Public Works Department

To: Development Community
From: Bruce Mills, PE, Deputy Public Works Director
Subject: **Supplement #1 to City Standard Specifications & Details**

The City of Kennewick Standard Specifications & Details is revised by these supplements as follows:

3-2
SHEET 1 OF 2

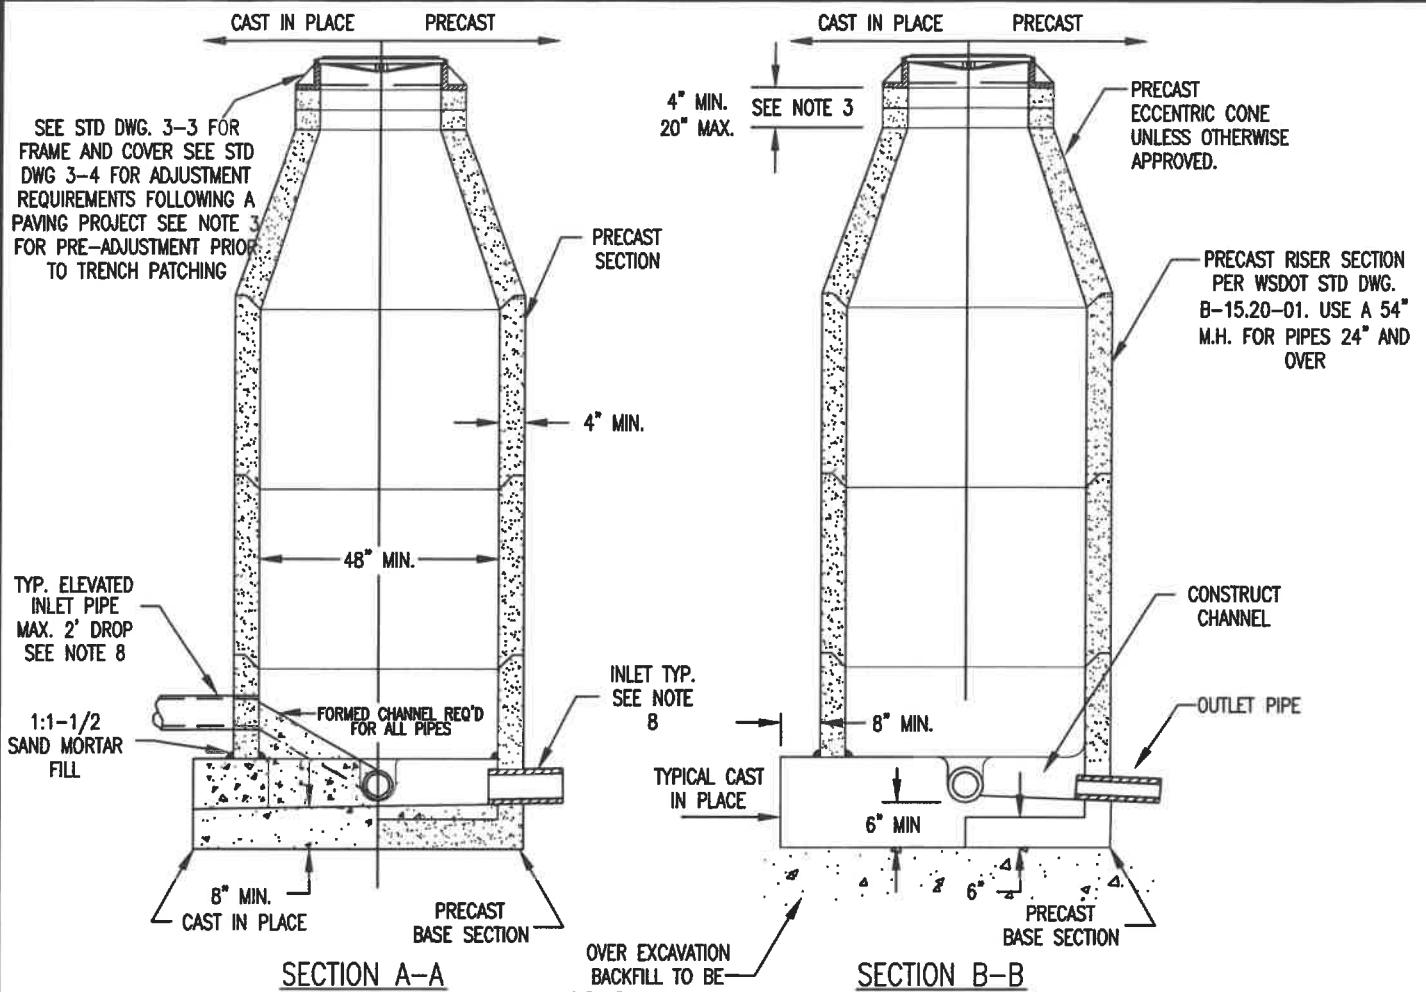
Detail 3-2, (sheet 1 of 2) Standard Manhole – Revised note to say "precast Concentric Eccentric Cone unless otherwise approved."

3-5

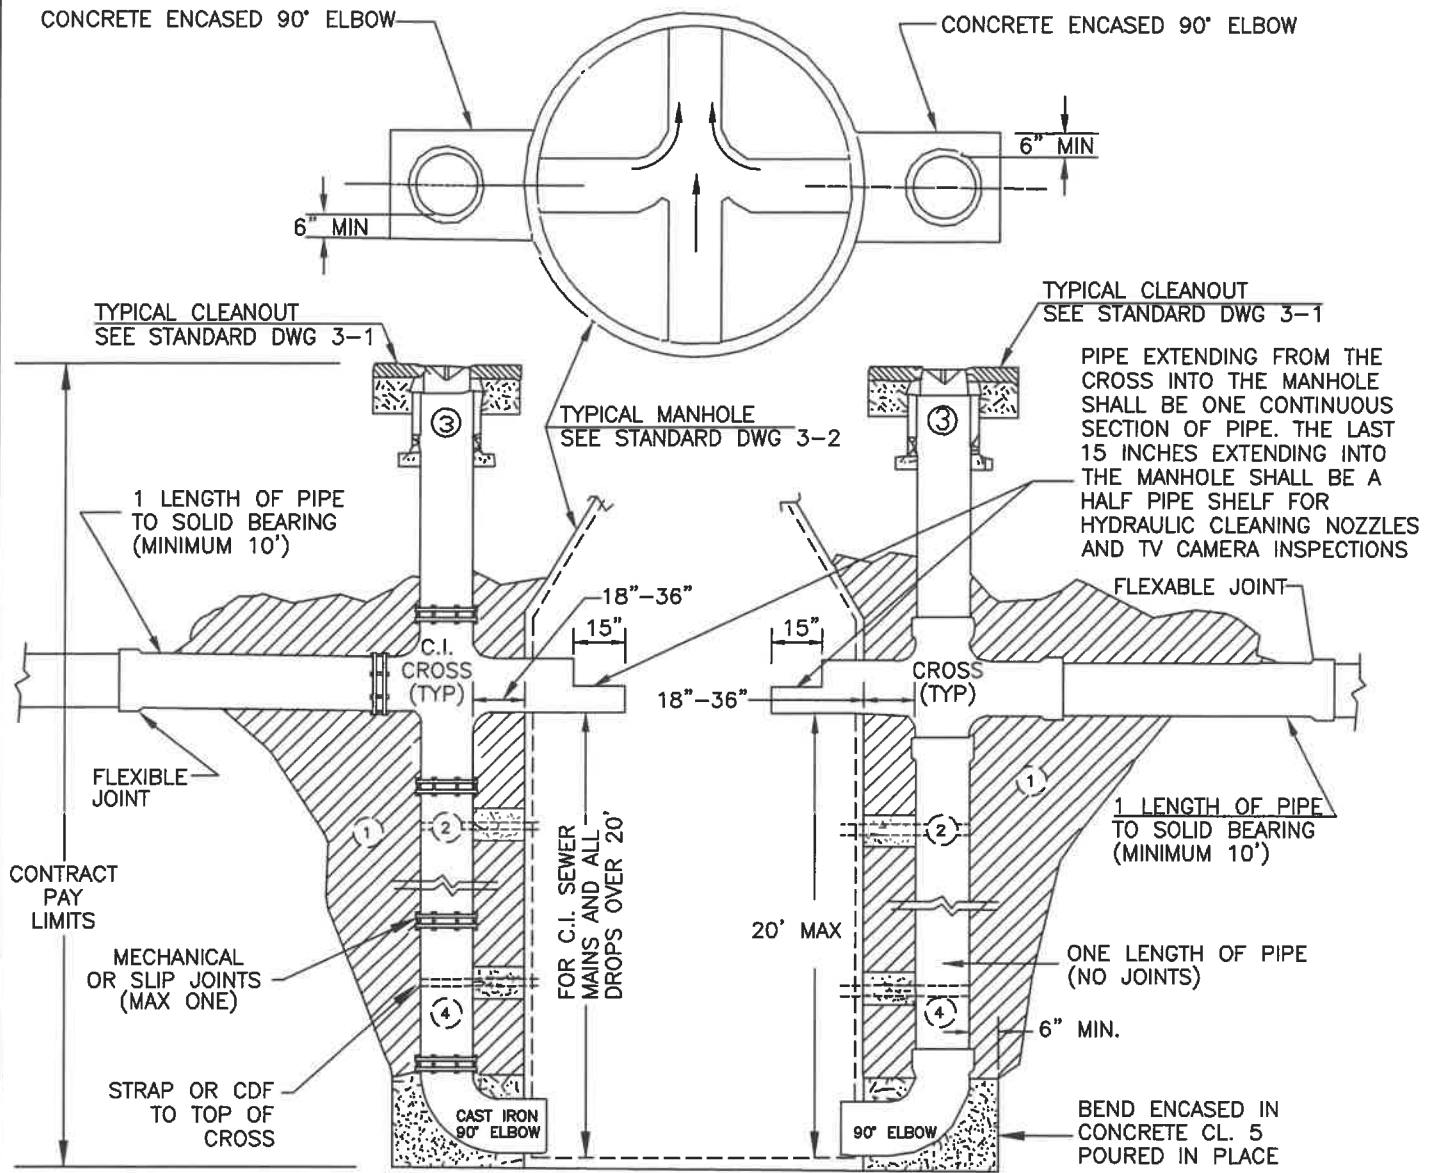
Detail 3-5, Inside Drop Connection – Removed the Inside Drop Connection as an option.

**OUTSIDE DROP CONNECTION
REQUIRED FOR INVERT DROPS OF OVER 2 FEET**

5-5

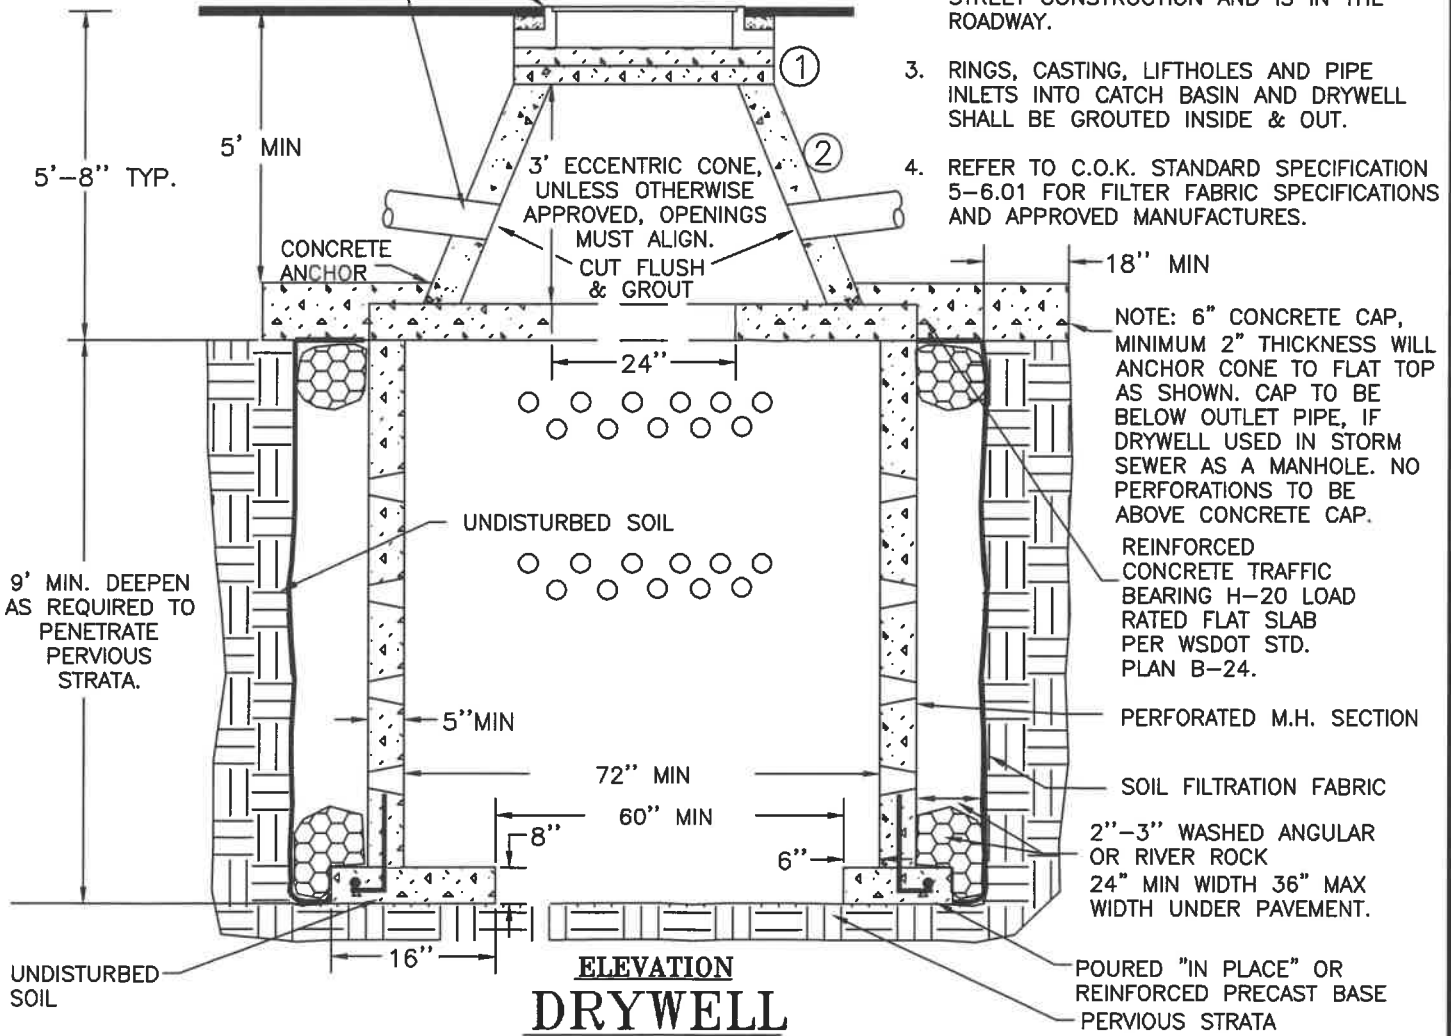
Detail 5-5, Drywell – Revised note to say "3' Concentric Eccentric Cone unless otherwise approved."
